CITY OF ALBUQUERQUE

RE: UNM Starbucks and Freddie's
Grading and Drainage Plan ^{MA}
Engineer's Stamp Date 1-27-2017 (File: K16D075)

Based upon the information provided in your submittal received 1-30-2017, the above referenced Grading and Drainage Plan cannot be approved for building permit until the following comments are addressed:

ENGINEER'S SEAL	STARBUCKS/FREDDY'S	DRAWN BY WCWJ
	GRADING AND DRAINAGE PLAN	DATE 12-27-17
	 1606 CENTRAL AVENUE SE SUITE 201 ALBUQUERQUE, NM 87106 (505) 872-0999	21702-LAYOUT-1-16-17
DAVID SOULE P.E. #14522		SHEET # —
		JOB # 21702

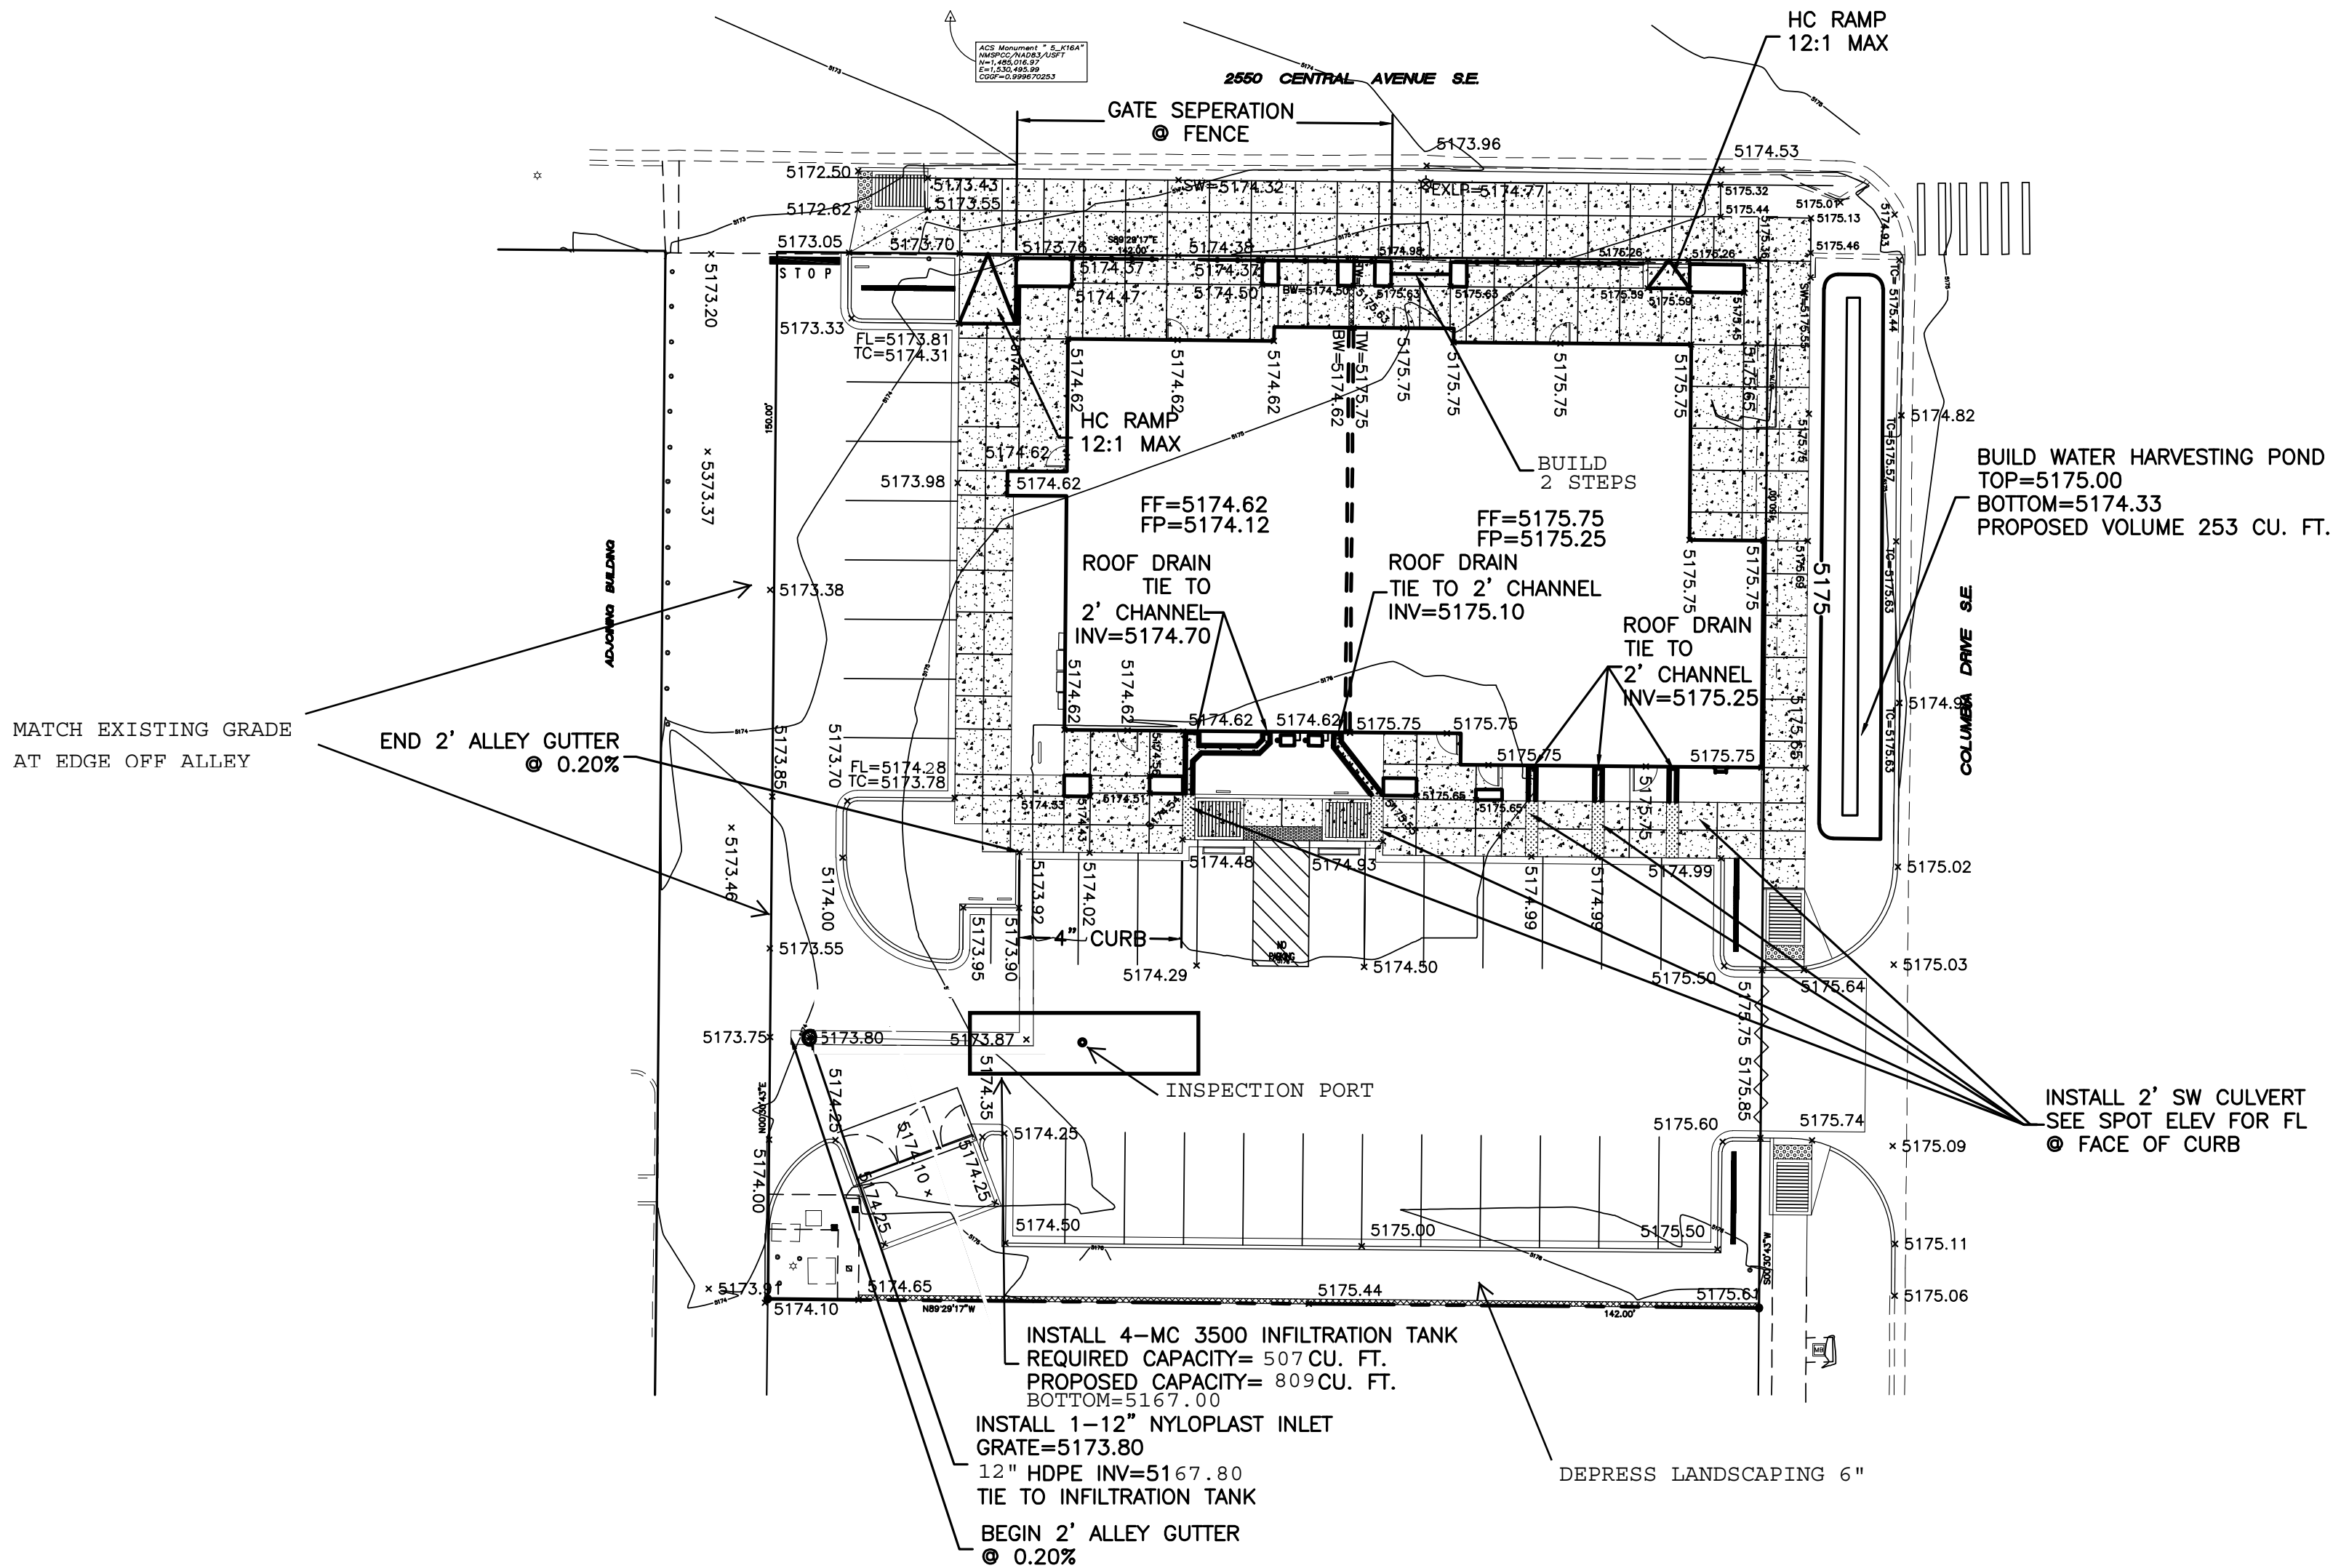
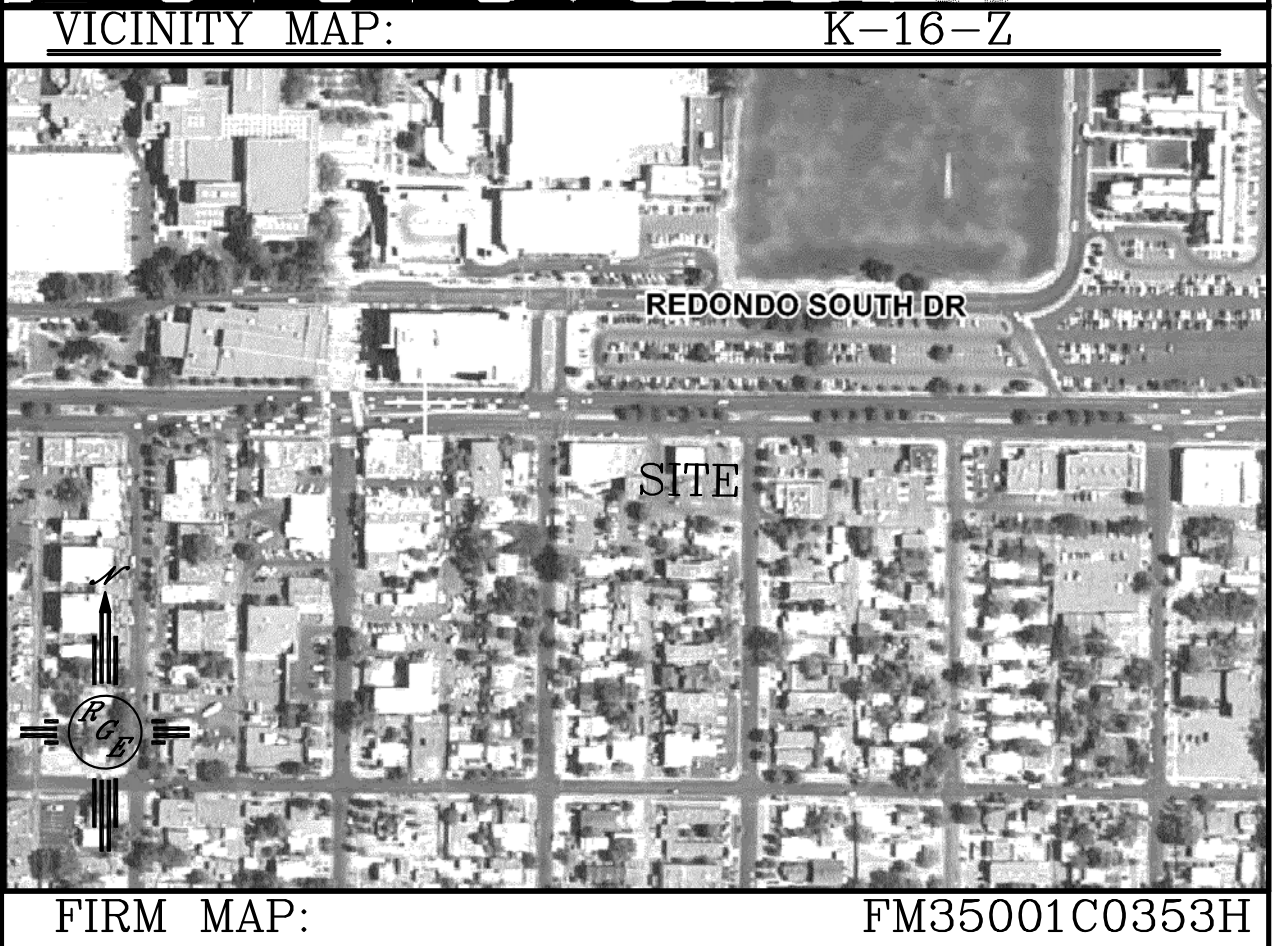
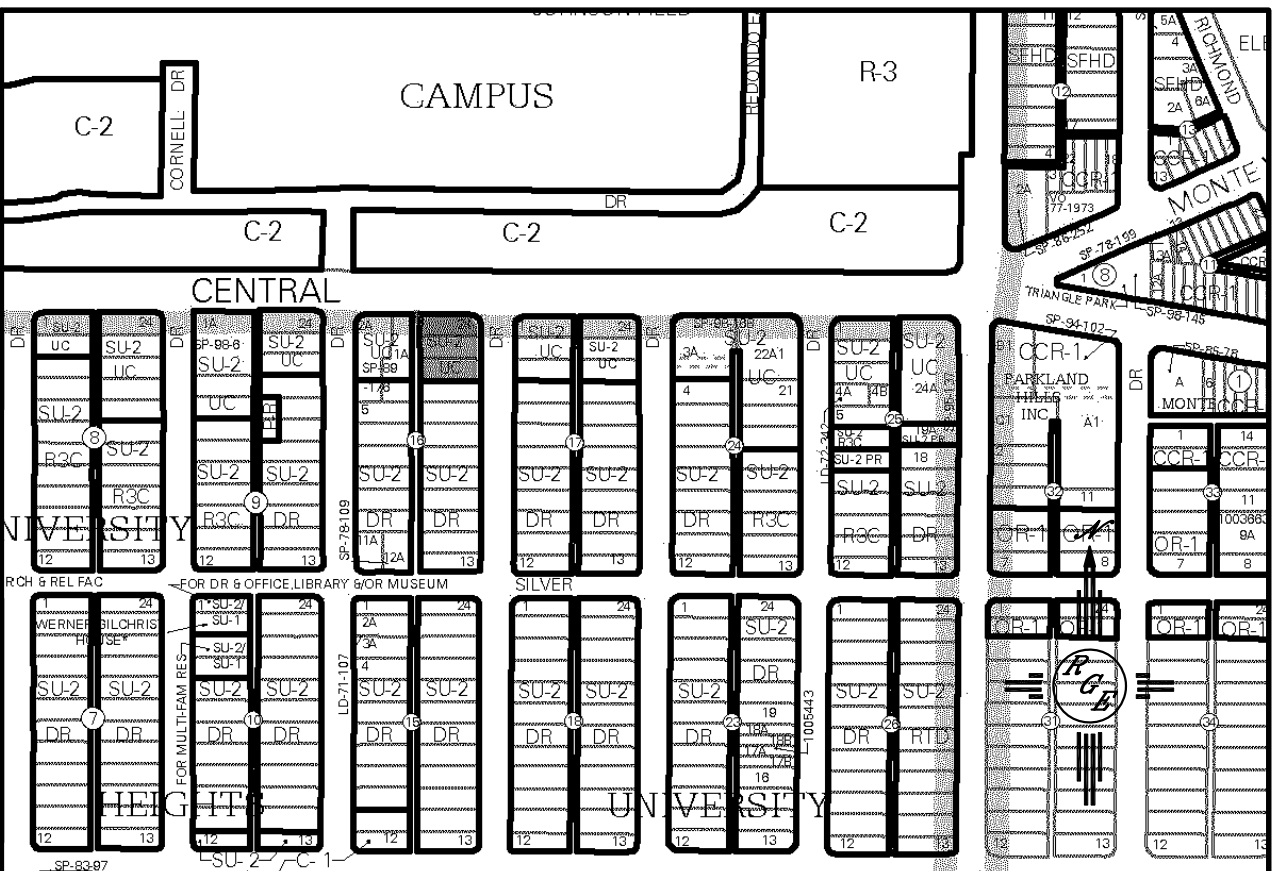
1. Provide build note and grade elevation for the dumpster.
2. Provide narrative for offsite flow.
